2023-2024 Transmission Plan

Foreword to Draft Addendum 1 to the 2023-2024 Transmission Plan

Figure 1: Single-line diagram of Imperial Valley 230 kV substation: a) Current Configuration

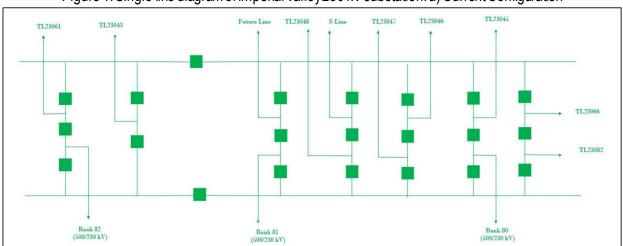
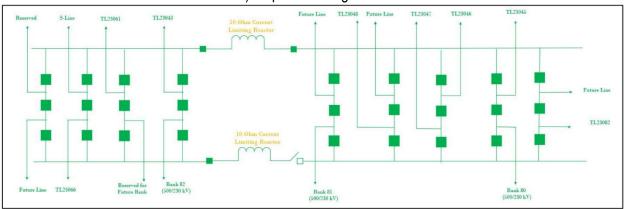
- Install two sets of 10-Ohm Current Limiting Reactors (CLRs) in series with the 230 kV buses, one on each bus;
- One CLR will be operated normally open; and
- Rearrange 230 kV transmission lines and move TL23043 Imperial Valley Westside Canal, TL23066 Imperial Valley – Drew, and IID owned S-Line Imperial Valley – Wixom SS to the west buses.

The estimated cost for this project is \$97 million with a targeted in-service date of June 2035. Figure 1 presents the single-line diagram of Imperial Valley 230 kV substation in its current configuration and with the proposed configuration. The ISO project will reduce the SCD at the Imperial Valley substation, as shown in Table 1, based on the short circuit analysis provided by SDG&E. Additionally, since these projects will result in the reconfiguration of the Imperial Valley substation, the ISO confirmed that they would not create new reliability concerns in the long-term scenarios.

Figure 2: Single-line diagram of Miguel 230 kV substation: Proposed Configuration

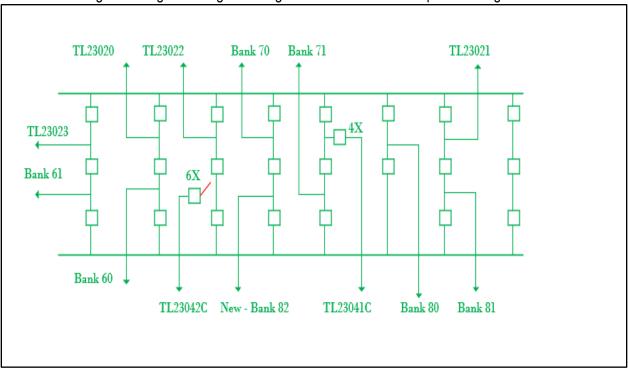
- Open Miguel 230 kV CB 6X;
- Operate TL23042C Miguel Miguel 6X Tap normally open;
- Modify TL 23041 / TL 23042 RAS to consider Miguel CB 6X status and upgrade RAS panel; and
- Install a 3-Ohm series reactor on TL23026 Silvergate Bay Boulevard 230 kV line which will be located at Bay Boulevard substation.

The estimated cost for this project is \$51 million with a targeted in-service date of June 2035. Figure 2 presents the single-line diagram of the Miguel 230 kV substation in its proposed future configuration by opening CB 6X.

During the evaluation process of the original project submitted by SDG&E in the Request Window, the ISO identified an increased loading in the Bay Boulevard – Silvergate – Old Town 230 kV transmission lines when Miguel CB 6X is operated normally open which could pose potential reliability and policy concerns. Thus, the final proposal includes the addition of the 3-Ohm series reactor on TL23026 Silvergate – Bay Boulevard 230 kV line, which mitigates this issue.
